**STATE SIGNIFICANT DEVELOPMENT APPLICATION SSD - 8950984
BURRENDONG WIND FARM – PROPOSED WIND FARM WITH UP TO 70
WIND TURBINES AND ASSOCIATED INFRASTRUCTURE**

The following is my comments only on the EIS supplied due to time constraints:

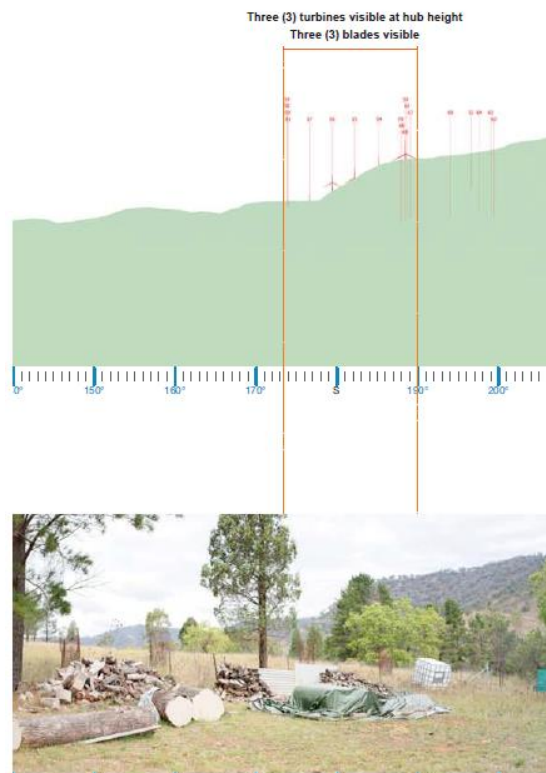
This is our mark up of missing non-residences from Worlds End area.

- The above map that Arc Energy did for the project does show other non-hosting residences so why eliminate non-hosting residences from Worlds End now for the submission?
- Based on the misrepresentation and omission of the non-associated dwellings this application must be refused.
- They say that the visual impact is negligible, very low or low. We have 400ha and of that 390ha have a front-line view of the WTG. We purchased our property to be away from infrastructure and for the vista and now we get wind turbines.
- The two maps below (A.2. U9-2 Assessment & A.5. U9-3 Assessment) were supplied to us by Moirs. Why are these maps not included in this EIS? The modeling by Moirs clearly shows significant impact to our property.

A.2. U9-2 Assessment

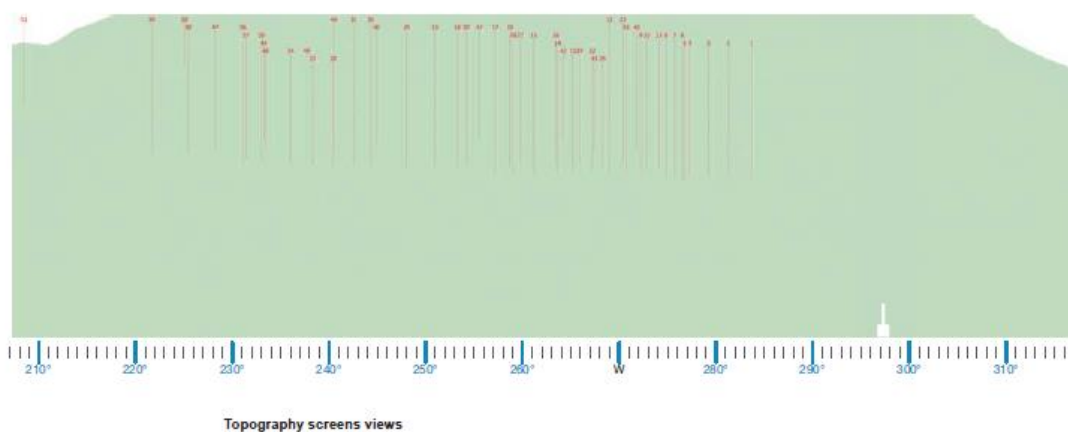
- This modelling from Moirs clearly shows impact to our property which is shown in the forefront of this photo. Why is this not included?

A.5. U9-3 Assessment

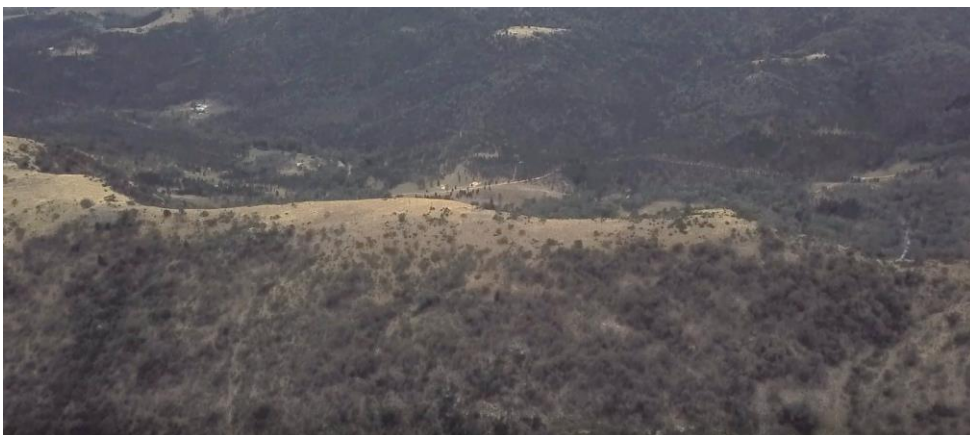
- Almost twenty-two WTG will be able to be seen from our residence at 430 Worlds End Rd Worlds End. They only need to be slightly higher and then we will see them all. So, if you move away from the dwellings on our property to the rest of the property you get full visual of the WTG.

- This image was taken in Nov 2020 showing the visual impact of the WTG (Epuron 2020). This map has also not been included in any of the reports.

Section of Figure 6-5. Highlighted area is the rough area of Worlds End

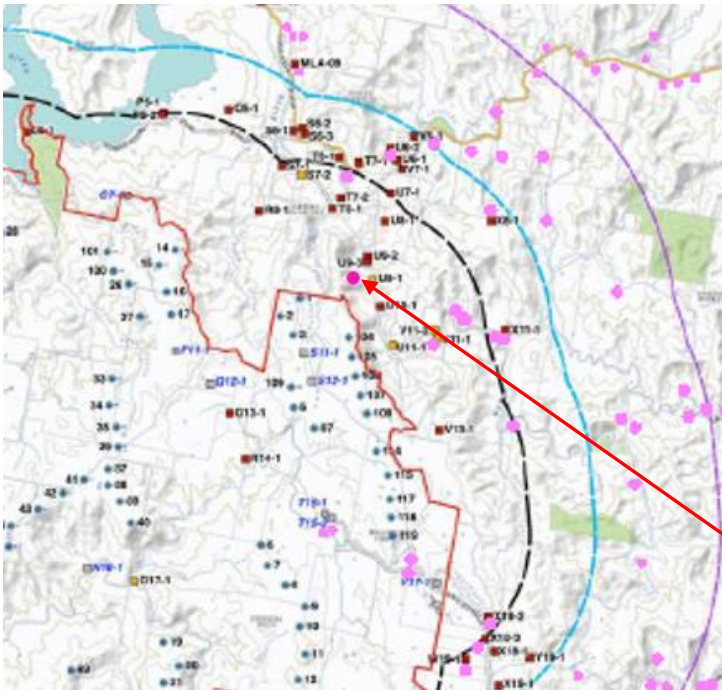
- Figure 6-5 Non-associated dwellings located within the Black and Blue Lines of Visual Magnitude. This map proves that they have no idea on what they are taking about as the seven identified residences in Worlds End are not in Worlds End but are in Yarrabin.

- So, now we are back to the fact that NO residences in Worlds End are recorded as being there.

- R8-1 T7-2 U8-1 S7-2 and U7-1 but our property U9-3 is not on the map. This incorrect exclusion needs to be corrected.

Missed Meroo Creek plus others.

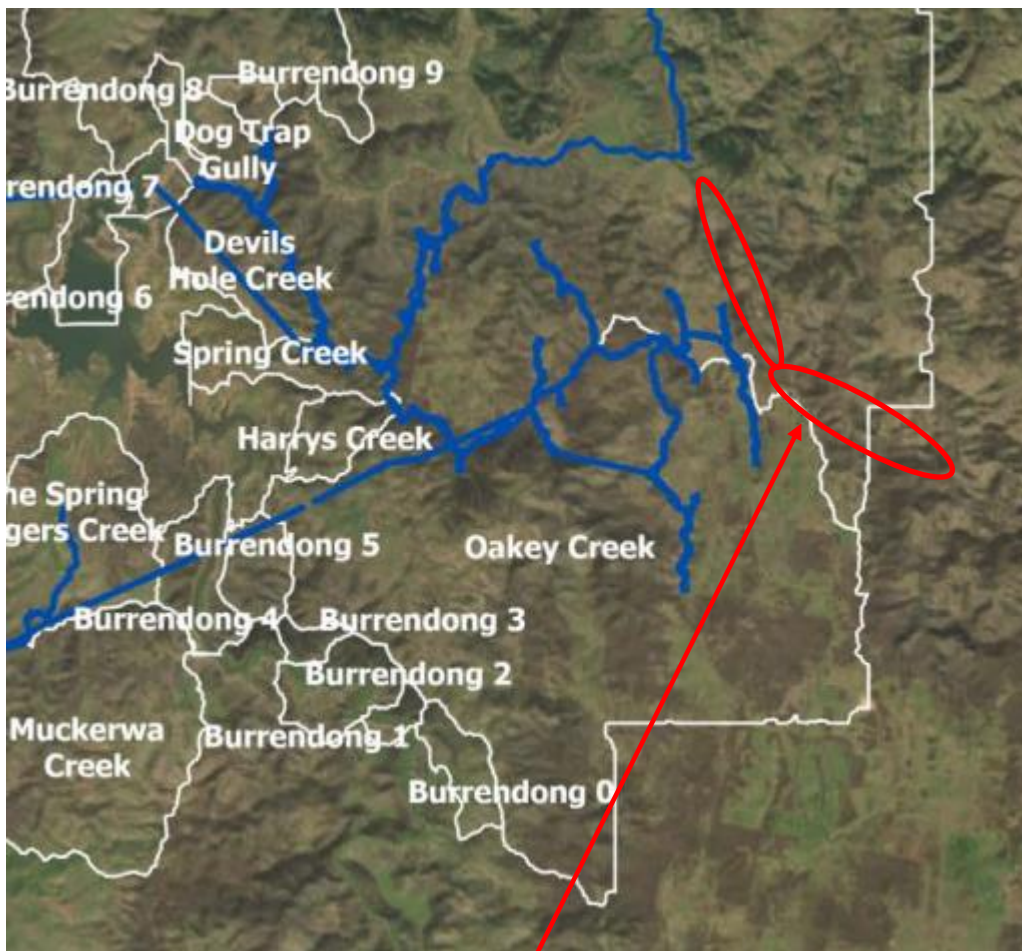
- After reviewing this catchment modelling, I believe this is so inaccurate. How can so many creeks and rivers be missing on the right hand side of the project?

Fig 6-71. Dwellings next to WTG.

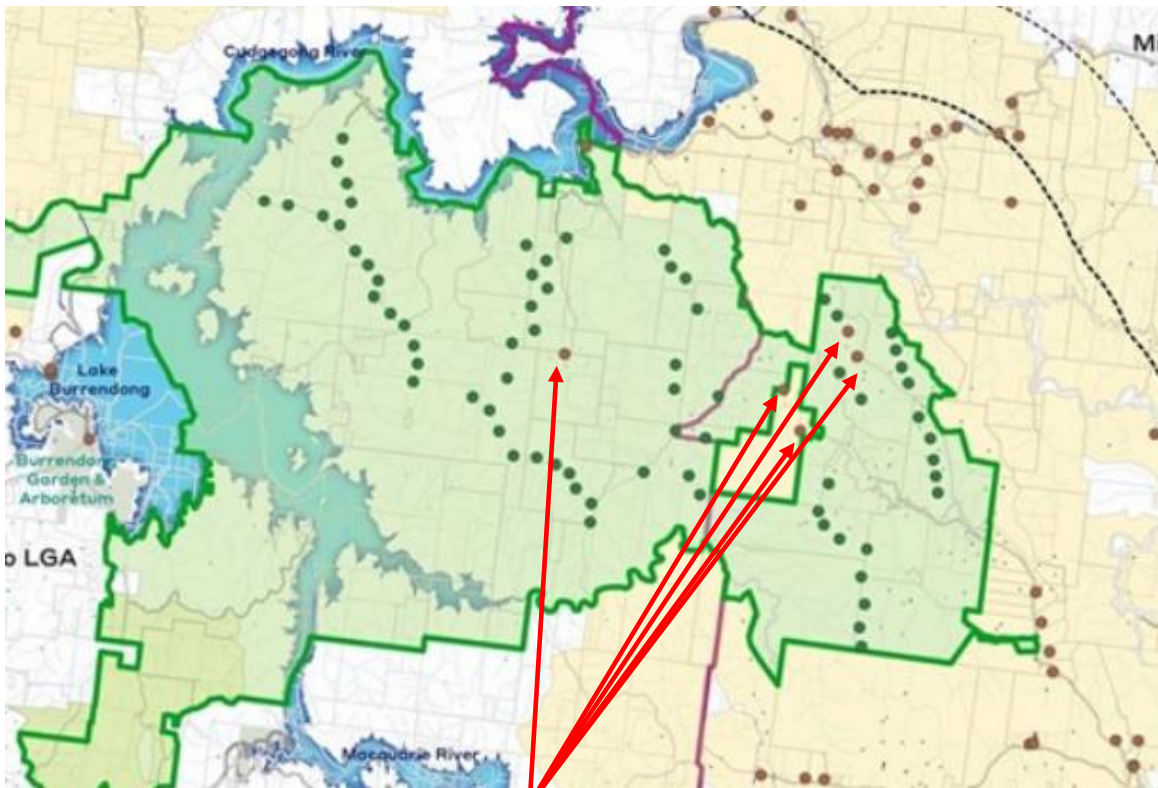
- According to figure 6.71 Worlds End residences and people do not exist. Also, by interpreting this figure, which has no scale in the map for measuring, there are five (5) dwellings (brown dot) within metres of the WTG. How can this happen? I thought there was a buffer zone from residences?

Fig 6-71 Some of the missing Residence

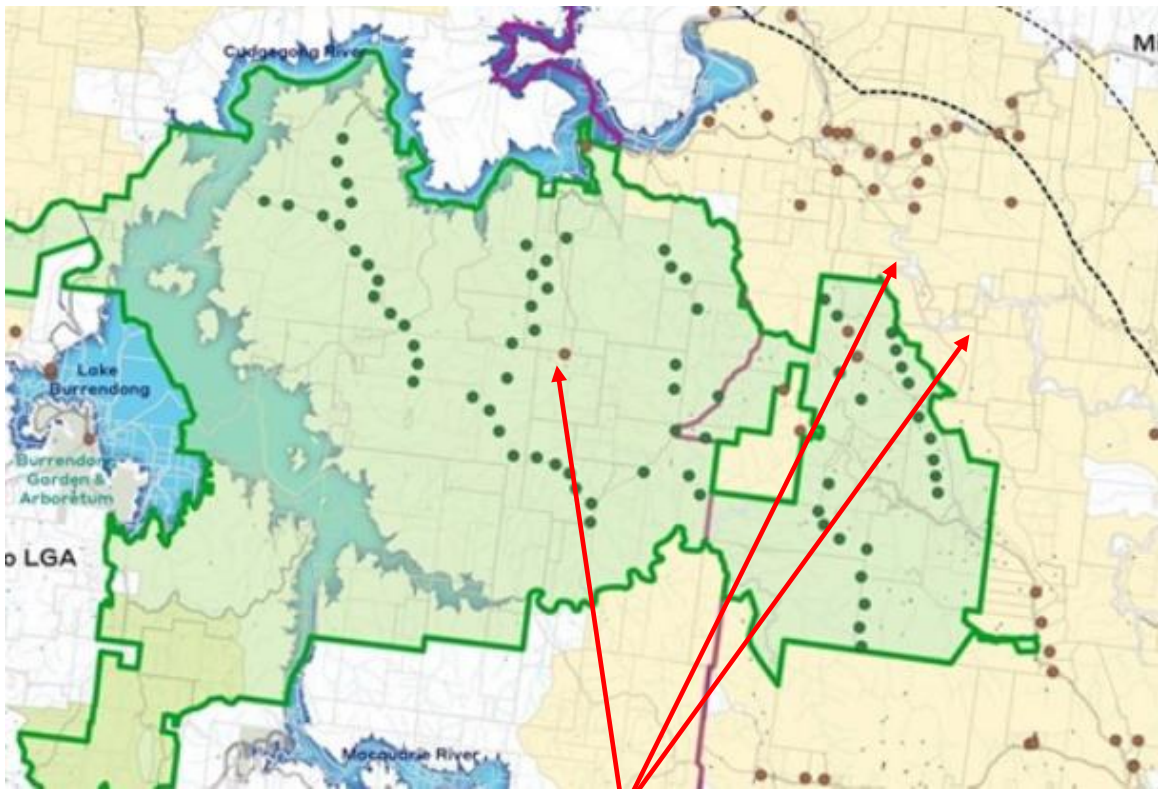
- Between the red arrows there is in excess of 20 residences missing from the data. In previous reports by both Epuron and then Ark Energy most of the residences were identified. Why are they missing here?

Figure 6-1: Visual magnitude analysis (Moir 2022)

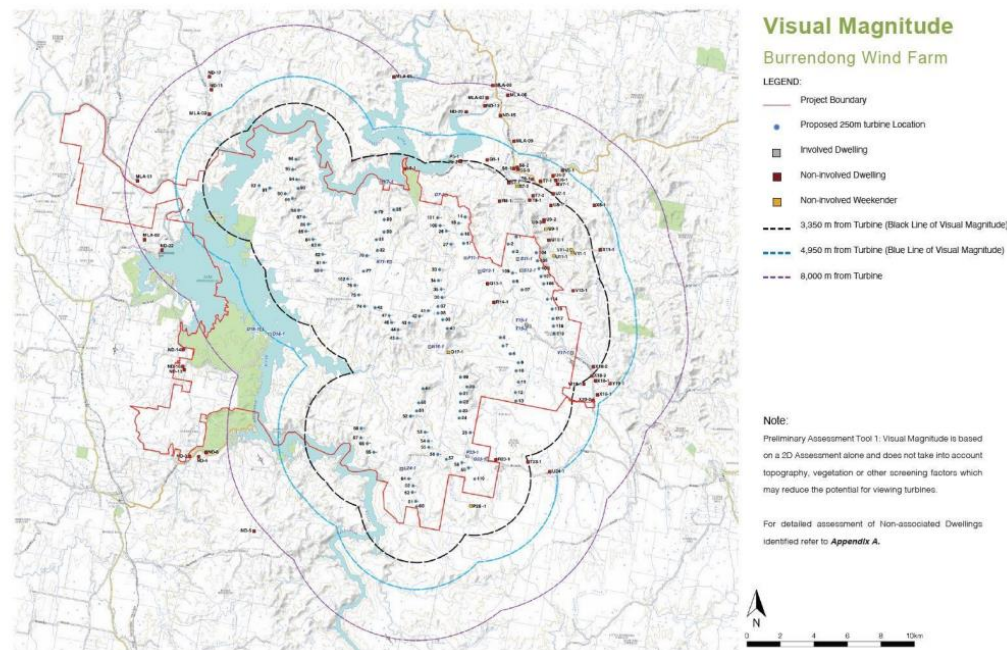
- The above map taken from the scoping report from Eco Logical shows many residences listed on this figure. Especially all of the residences in Worlds End. As per normal all of the maps from Eco Logical are hard to read so I have taken a section that shows residences in Worlds End that they appear to have removed on purpose.

Figure 6-1 Visual magnitude analysis Scoping report Eco Logical page 70 close up view.

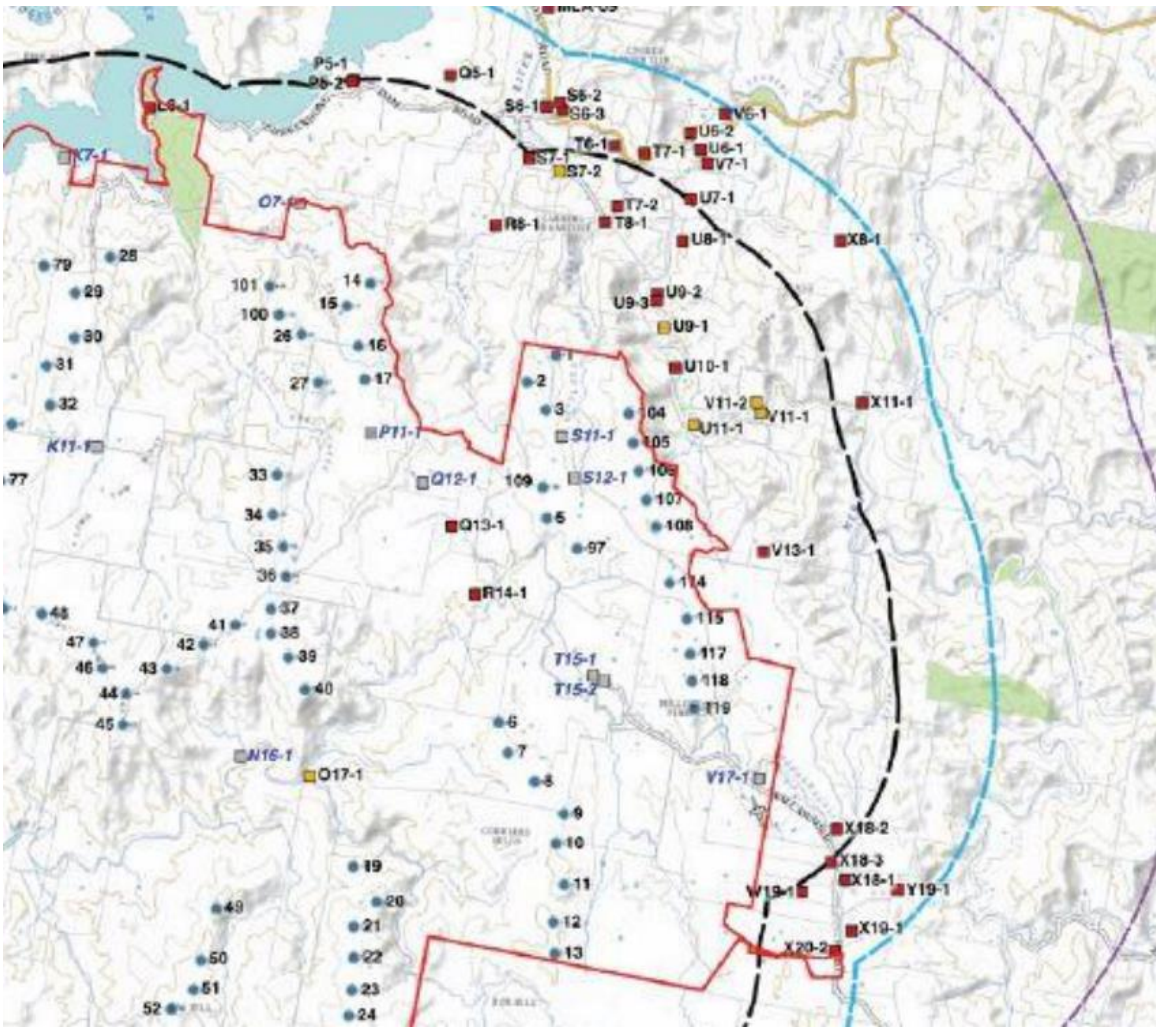
- As the numbers are blurry the following are some of the properties that have been intentionally left off from all components of this EIS report. This list is not the entire missed residences that were previously identified by Arc Energy and Eco Logical.
 - T7-2
 - U8-1
 - U9-2
 - U9-3
 - U9-1
 - V10-2
 - V11-2
 - V11-7
 - V11-1
 - V13-1
 - X11-1
- So, one must ask why has Arc Energy and Eco Logical made a misrepresentation to this magnitude in this EIS report?
